# GXV3380 Firmware Release Notes

## FIRMWARE VERSION 1.0.3.27

GXV3380

04/06/2021

### ACCOUNT SETTINGS IMPROVEMENT

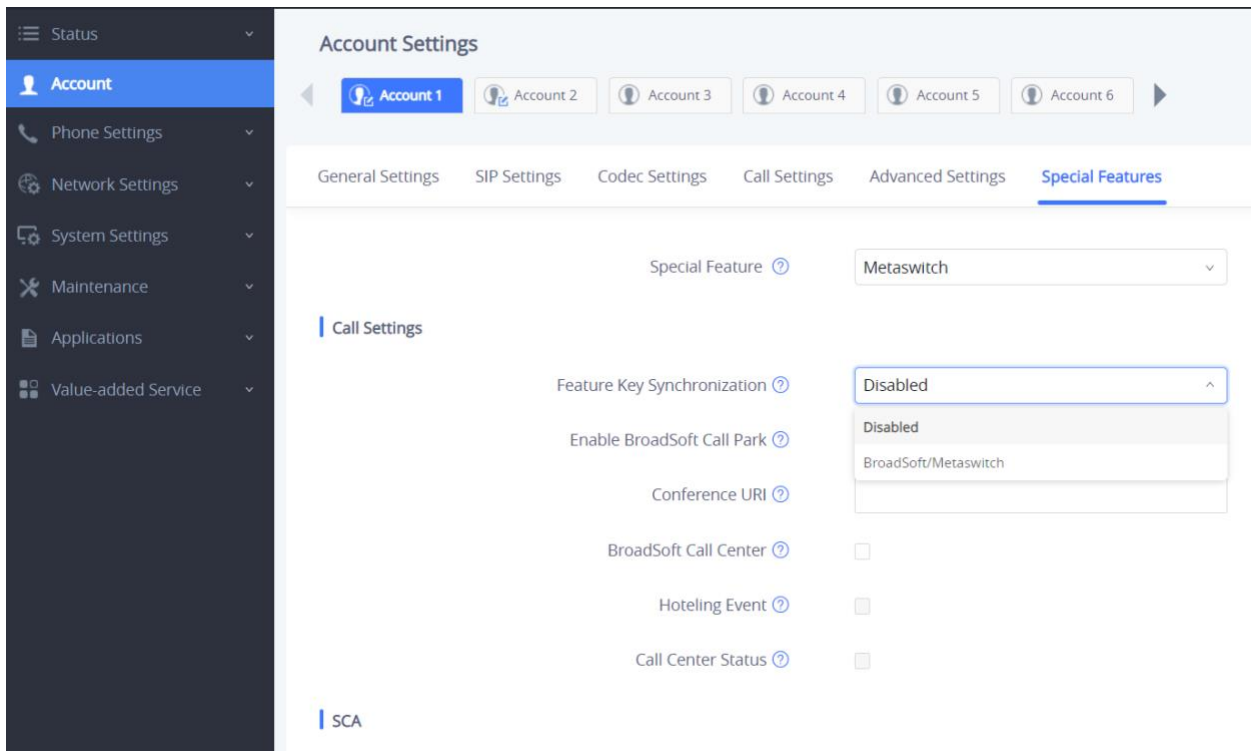
Special Feature tab can be now found under Account settings for each account, where Special Feature, Call Settings and SCA can be found. Feature Key Synchronization setting option to "Broadsoft/Metaswitch". Please find the new layout below.
